SCOTT DRIVE AND VEIRS DRIVE SHARED USE PATH CITY OF ROCKVILLE FEASIBILITY STUDY

City of Rockville December 22, 2023

Scott Drive and Veirs Drive Shared Use Path, City of Rockville Feasibility Study

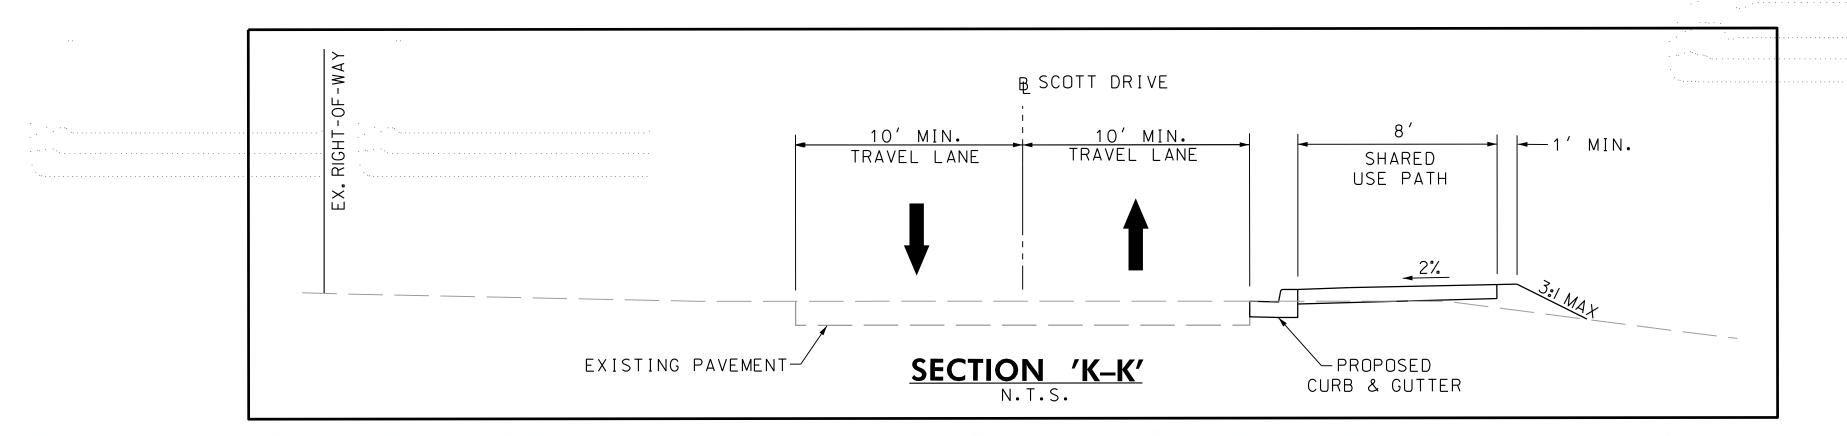
Four Acer rubrum trees here in decline.
Removal will probably

be necessary

Healthy Juglans nigra tree located here, would need to be removed under current plans but would like to prioritize retention as possible.

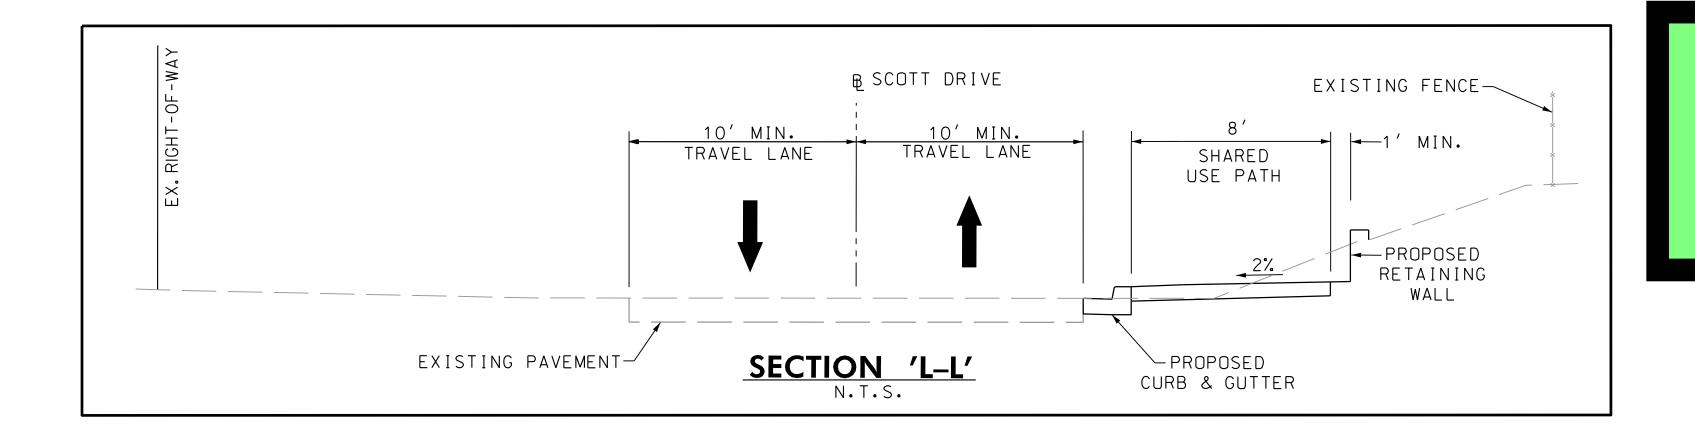
Mature Prunus spp. tree- priority retention

Mature Liriodendron tulipifera tree in this area would have CRZ impacts

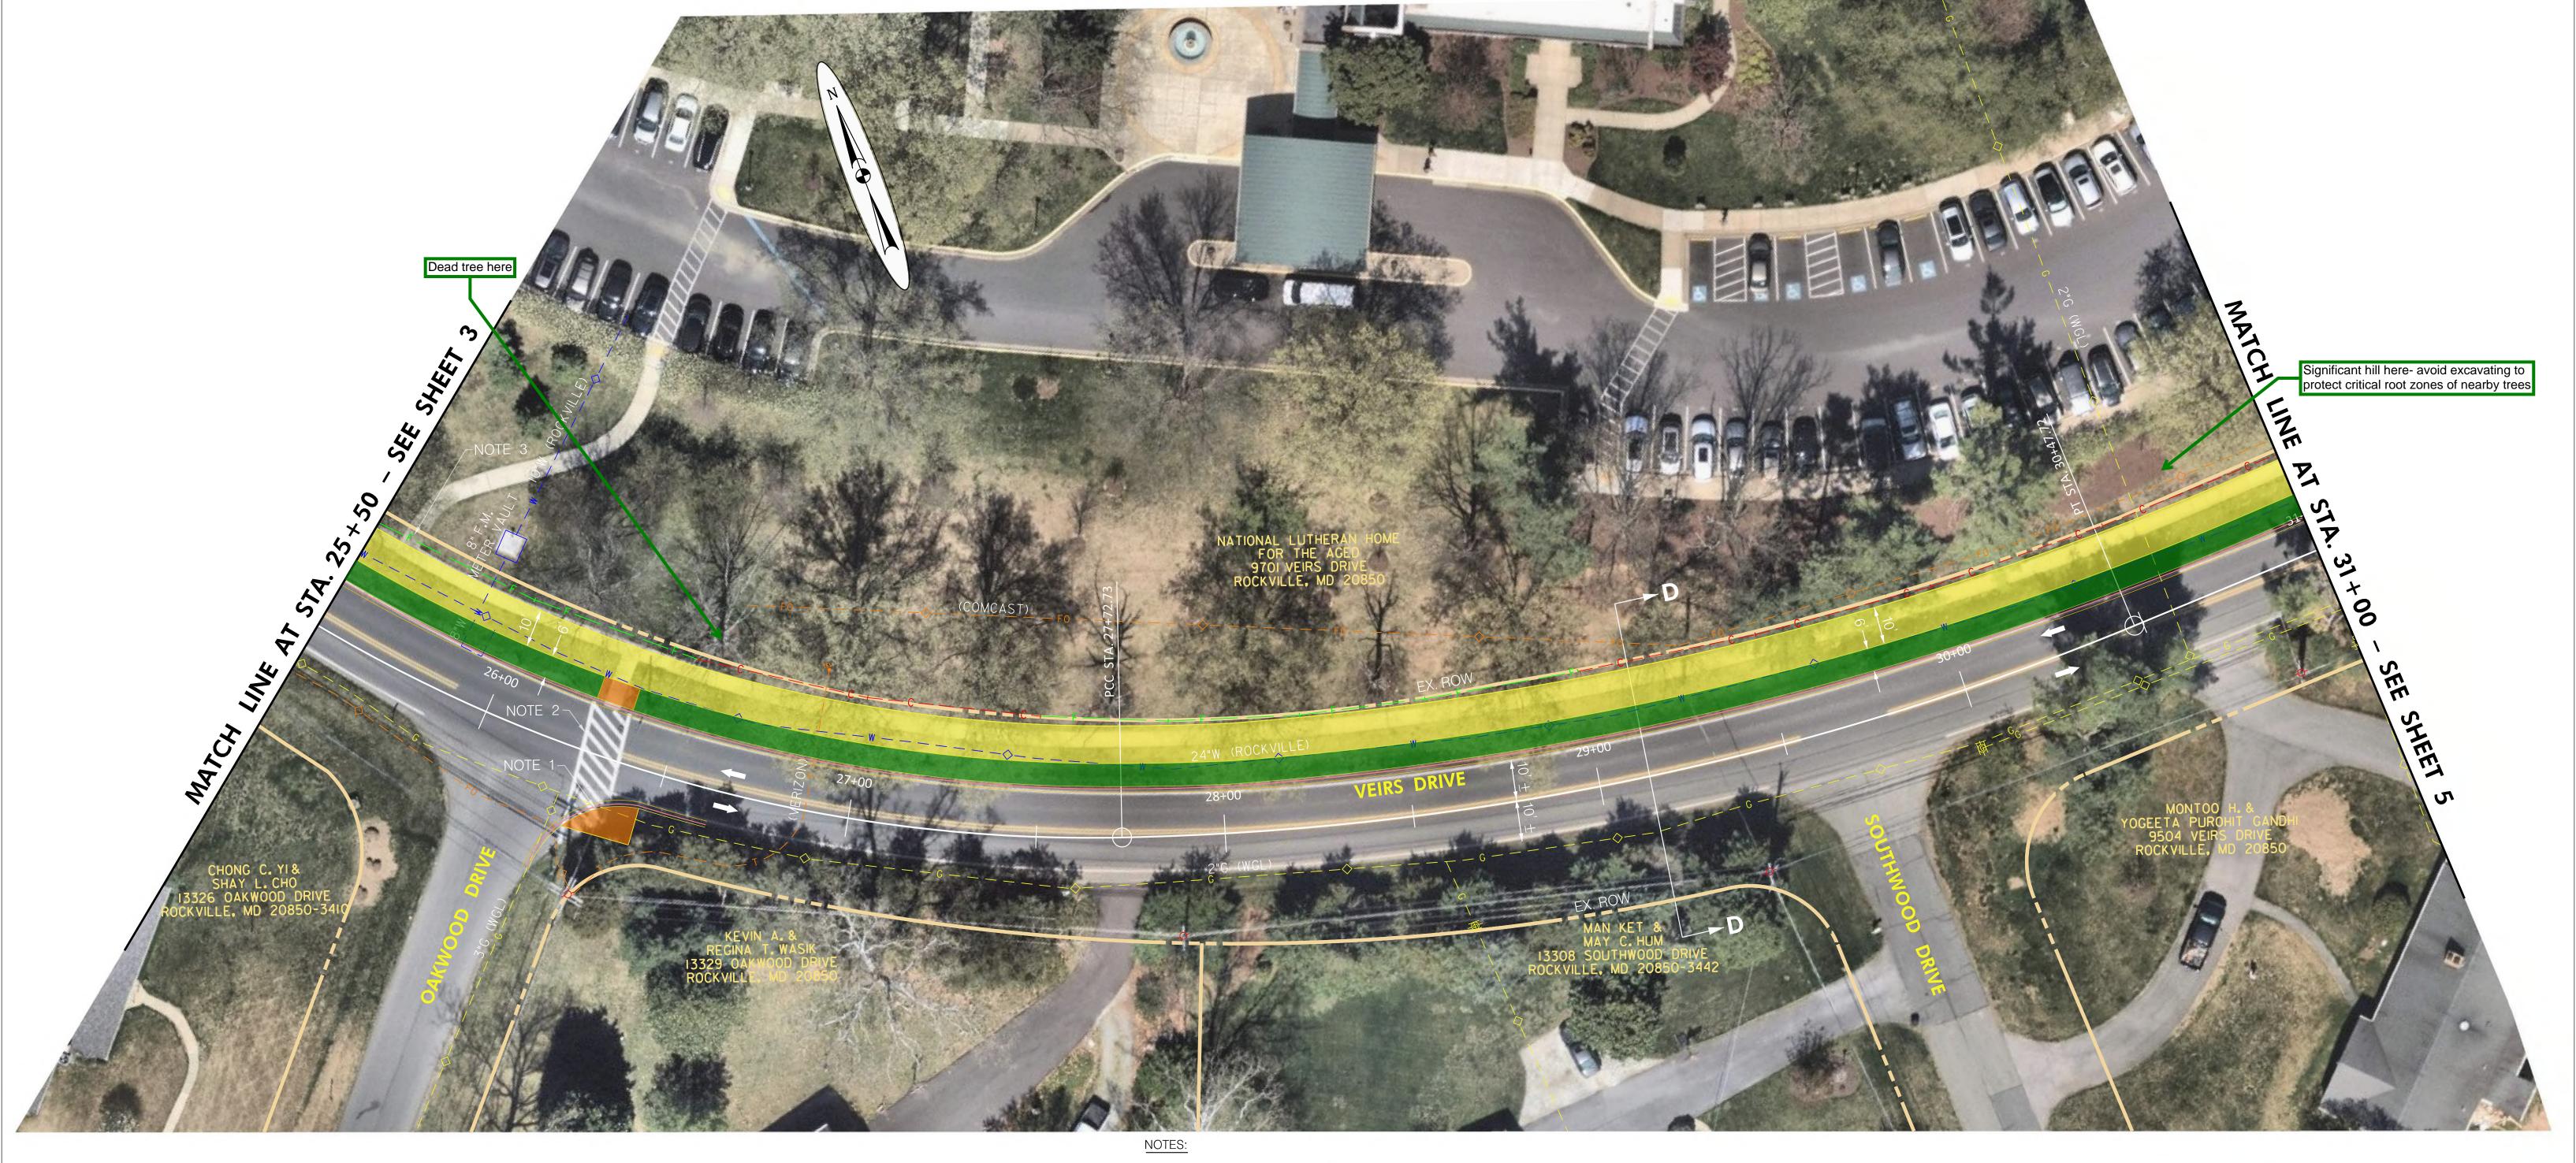
Many declining Quercus palustris trees along the National Lutheran Home property. Could potentially be removed and replaced with significant tree replacement requirements.

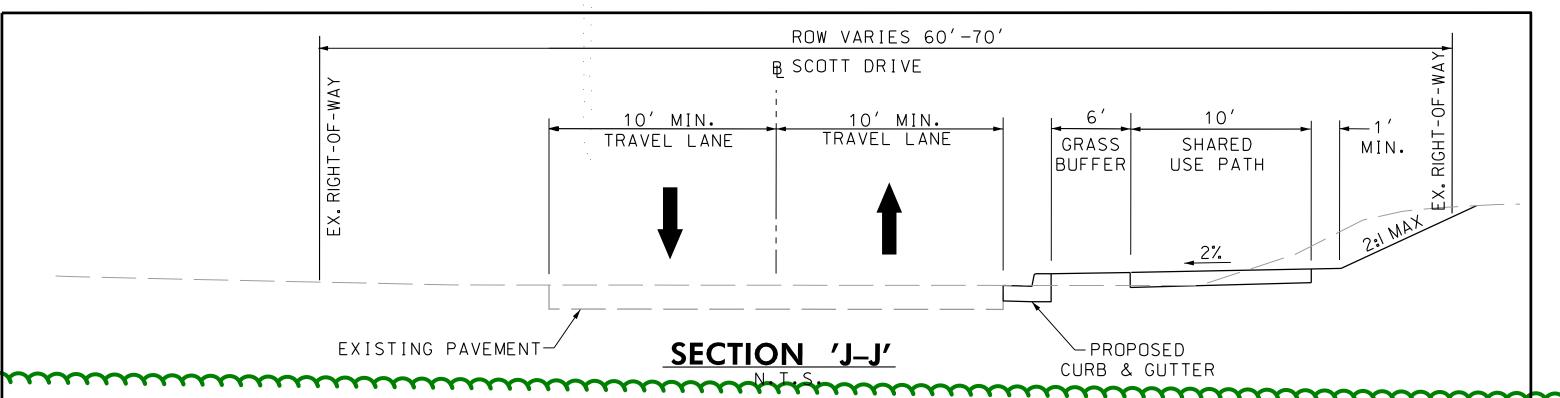
This is city property

SEE There is room for the path to curve away from

— — w — − EX. WATER — — SAN — EX. SEWER — — FO — - EX. FIBER OPTIC Many invasive overgrown plants here, but some trees in good condition. Some healthy Ginkgo biloba, Platanus occidentalis, and Juglans nigra trees
